**Report: PRELIMINARY TAB REPORT**

**Function: Test, Adjust, & Balance**

**Date: 10/17/2024**

## 10-14-24 ULTA 1697 SELMA, NC

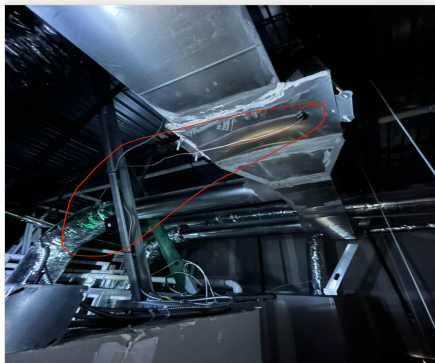
**Issue Name :** EF-2 Dampers not installed  
**Description :** EF-2 dampers are not installed. However the airflows are proportional so they likely will not be required.  
**Created By :** National TAB                      **Assigned To :** National TAB - Dan Hertenstein  
**Status :** Open  
**Priority :** Low                                      **Asset Tag :** EF2  
**Originated Date :** 10/17/2024 - Will Turnbough - National TAB

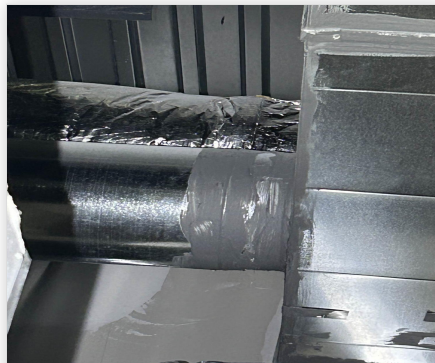
**Issue Name :** EF-2 Restroom fan unable to access  
**Description :** EF-2 speed controller is located above hard ceiling and is inaccessible. Unable to reach from other side with ladder due to piping obstructing access. The unit is running at 117% of design.  
**Created By :** National TAB                      **Assigned To :** National TAB - Dan Hertenstein  
**Status :** Open  
**Priority :** High                                      **Asset Tag :**  
**Originated Date :** 10/14/2024 - Jearod Ferrette - National TAB

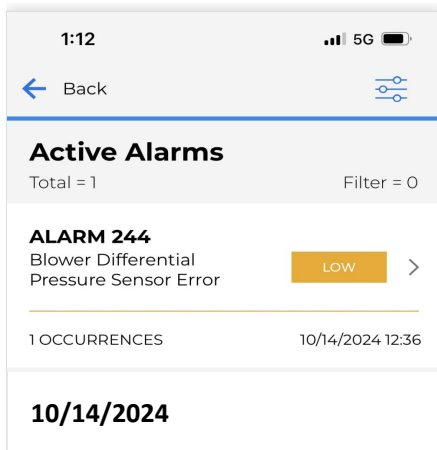
**Issue Name :** RTU -4 airflow is 149% of design  
**Description :** RTU-4 airflow is 149% of design. Unable to slow unit down with the CORE controller. There is an alarm code 244 (Blower differential pressure sensor error) that appears to be preventing speed adjustment.  
**Created By :** National TAB                      **Assigned To :** National TAB - Dan Hertenstein  
**Status :** Open  
**Priority :** High                                      **Asset Tag :** RTU4  
**Originated Date :** 10/14/2024 - Jearod Ferrette - National TAB

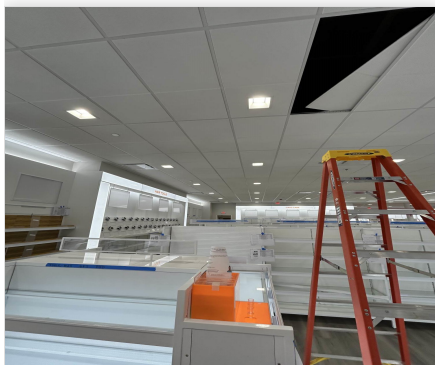
**Issue Name :** RTU-2 airflow is 72% of design  
**Description :** RTU-2 airflow is 72% of design (3435 CFM at diffusers) with motor at FLA. The duct is installed as 24"x18" inner dimensions but plans show 30"x20". Duct traversed as 3819 CFM. Velocity is 1273 FPM which is high. There is also an additional 90 degree transition installed. A larger motor would be required to achieve design.  
**Created By :** National TAB                      **Assigned To :** National TAB - Dan Hertenstein  
**Status :** Open  
**Priority :** Urgent                                      **Asset Tag :** RTU2  
**Originated Date :** 10/15/2024 - Jearod Ferrette - National TAB
